APPLICATION FOR A CONDITIONAL USE PERMIT FOR EARTH MATERIALS EXTRACTION – MSB 17.30

Facility/Business Name: Mountain Gravel Pit

On behalf of Mountain Gravel Investment Group, LLC, The Boutet Company has prepared the following submittal in pursuit of a Conditional Use Permit for Earth Materials Extraction with the Matanuska-Susitna Borough. The proposed gravel extraction is located on two lots located at 8751 and 8901 E. Palmer Wasilla Highway (PWH) having legal descriptions Township 18N Range 1E Section 35 Lot C6 and C9. The lots have a total area of 13.16 acres of which the gravel extraction will occur on the easter 5.96 acres. The gravel extraction will remove a ridge that runs east to west through lot C6 and terminates in lot C9. The extraction will remove material to an elevation near the existing elevation of the Palmer Wasilla Highway to prepare it for future commercial and/or multifamily development.

SHEET **3 / 7**

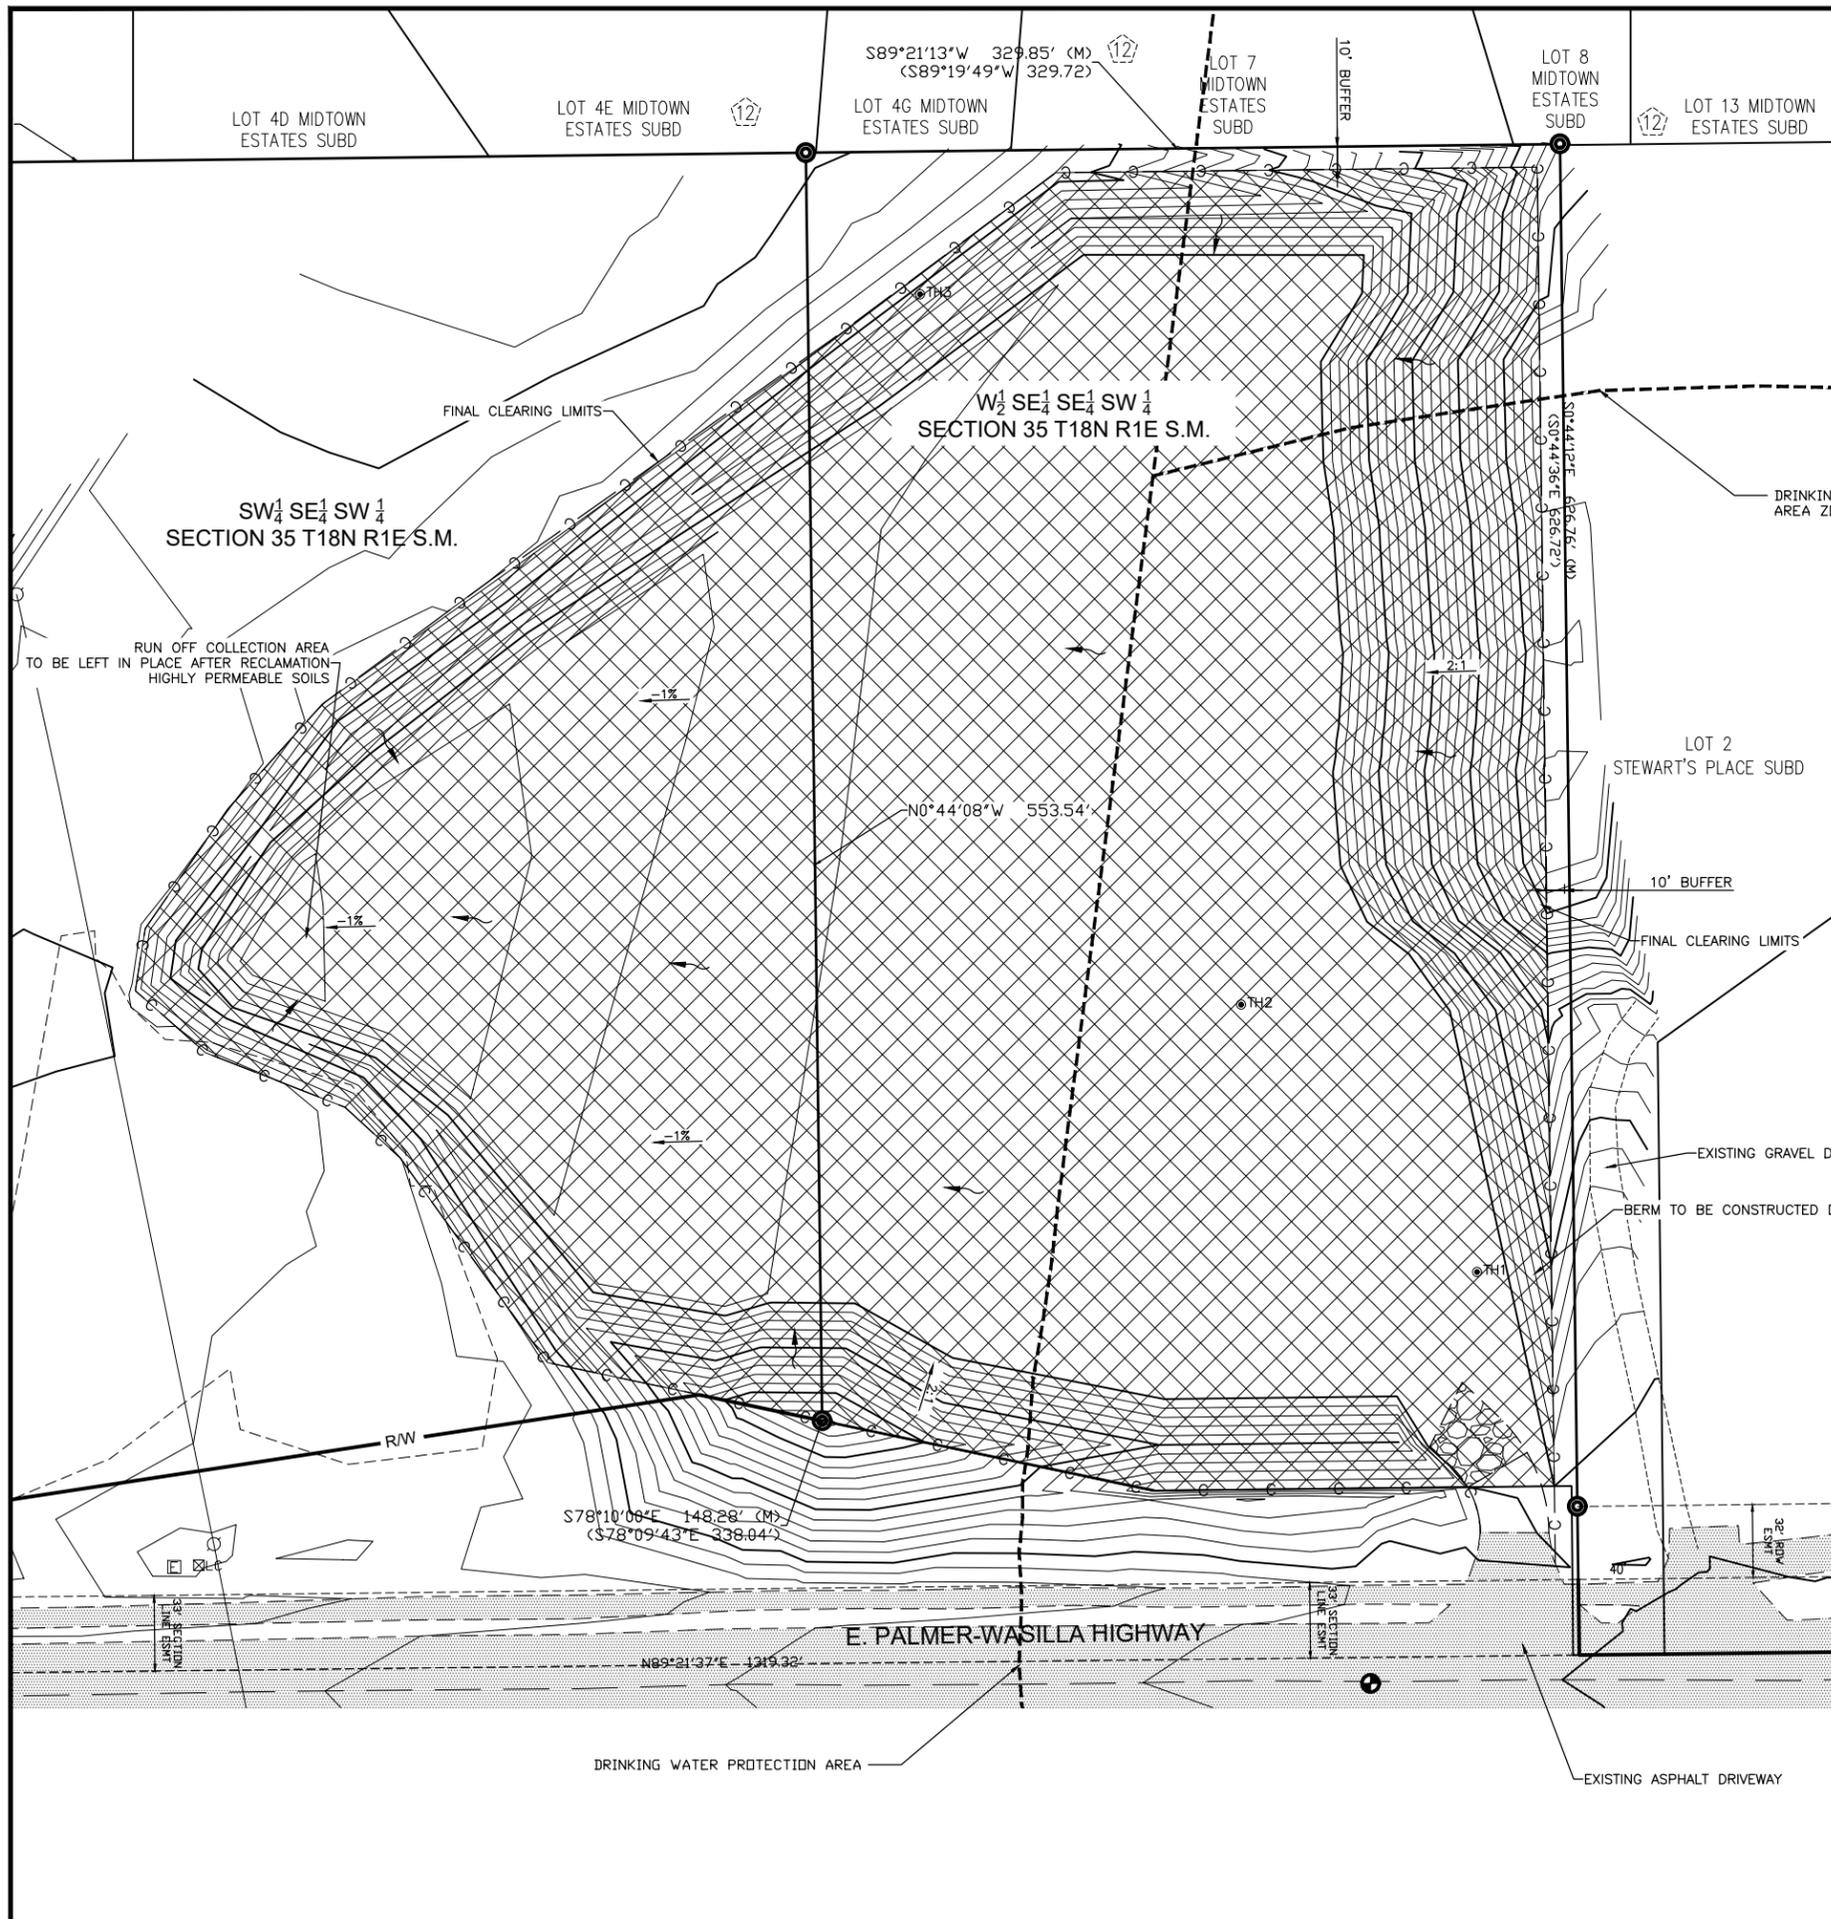
9. Comment: The reclamation sheet 4/6 shows the existing topographic contours. This is confusing because when reclamation is occurring, the topography will have changed.
a. This may be resolved with a phone call to require my understanding.

Response: The Final excavation and reclamation surface are the same with the exception of adding 4" of topsoil to stabilize the slopes. Due to this, the final ex topography will not appear any different than the reclaim surface.

8901 E. PALMER WASILLA HWY.
GRAVEL EXTRACTION
GRAVEL EXTRACTION
CROSS SECTIONS

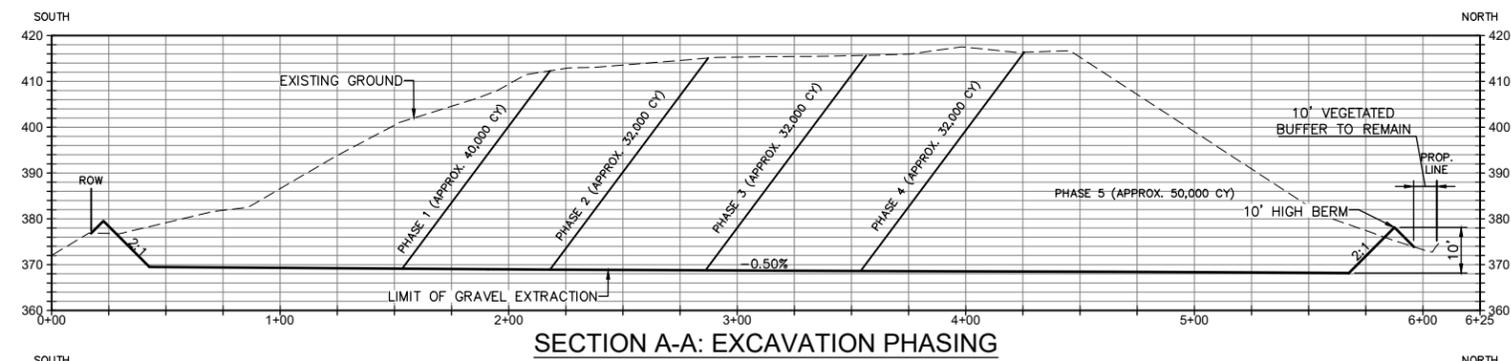
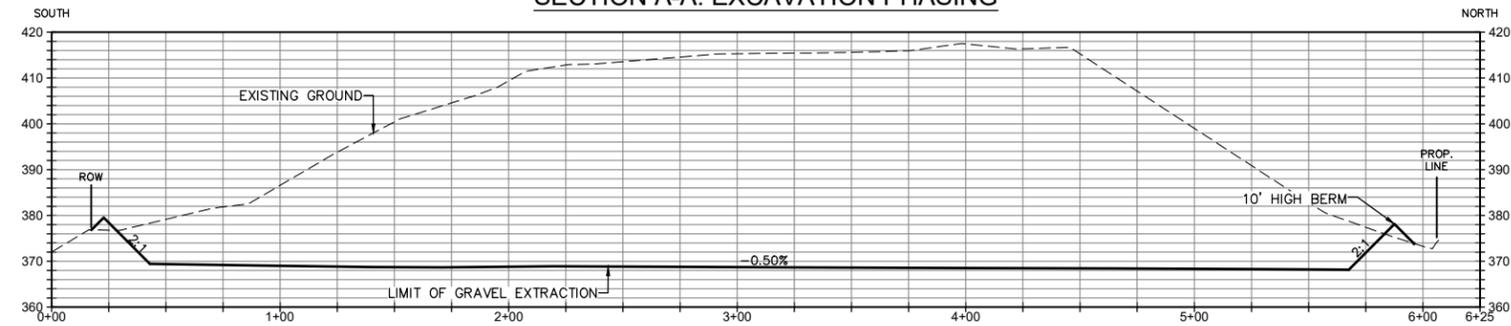
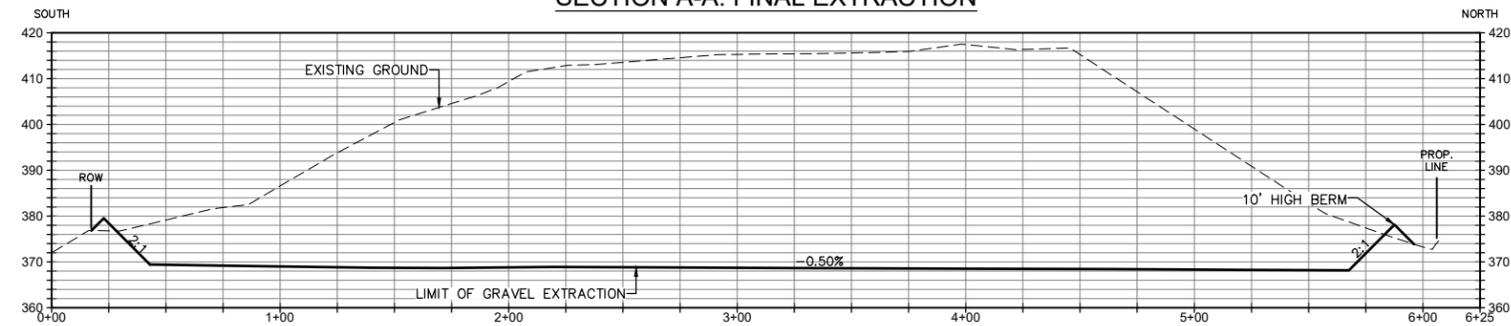
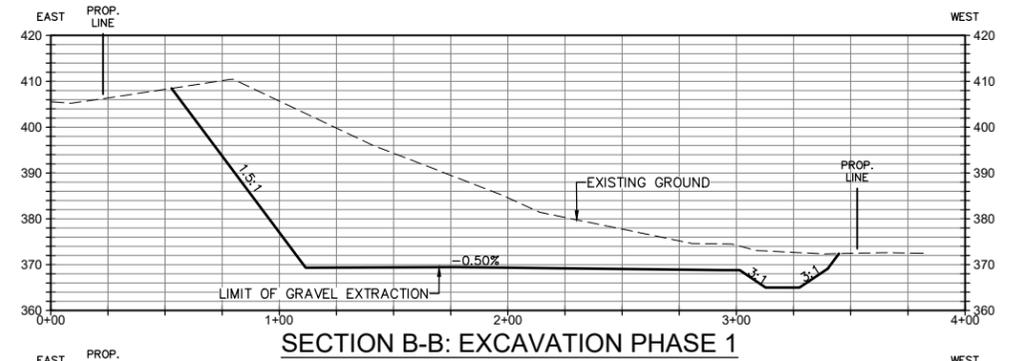
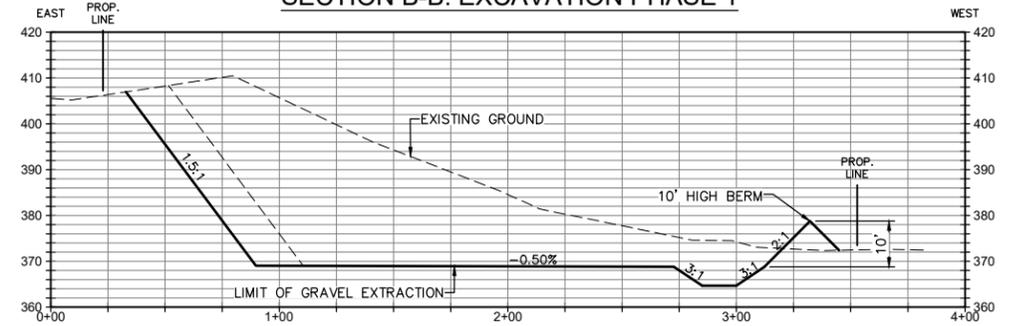
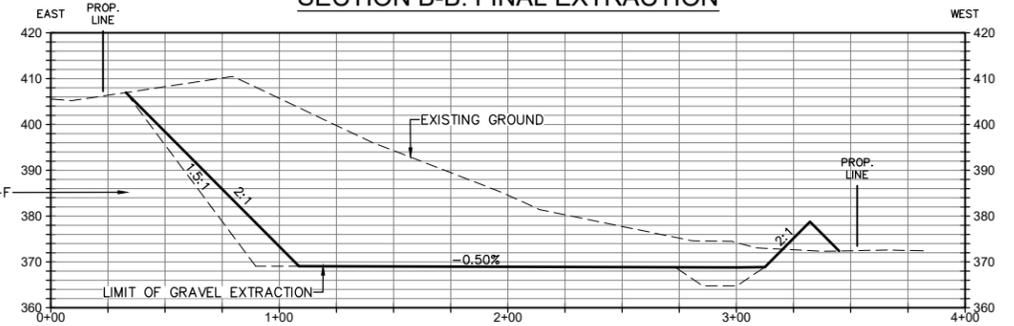
13. Comment: The slopes proposed for the side of the excavation and for the visual and noise buffers appear to be very steep and may sluff material causing erosion of the buffers and slopes. Within the Borough, the normal angle of repose for sand and gravel has been 1.5:1 to 2:1.
- a. Provide a professional examination of material conditions that would allow an angle of repose to be 0.5:1 slope.

Response: Slopes have been redesigned to be a maximum steepness of 2:1. The visual and noise buffer berms will be composed of topsoil, roots and stumps and will be stabilized with seed. As such, the woody debris within the berms will provide additional stability to the soils and seeding will prevent erosion during gravel extraction. Furthermore, extraction will remain 30' from the property boundary until phase 6 and the final phase. It is intended that during these phases slopes will be excavated to their final limit and be reclaimed within the same year. In this way, any erosion of slopes will remain on property and will not damage neighboring lots until the slopes are completed and stabilized. The onsite materials are stable, temporarily at a 1.5:1 slope and could erode during spring thaw. With this in mind, we have added an option for removing gravel on side slopes up to 1.5:1 with the requirement that they be built out to a 2:1 prior to seasonal shutdown the same year.
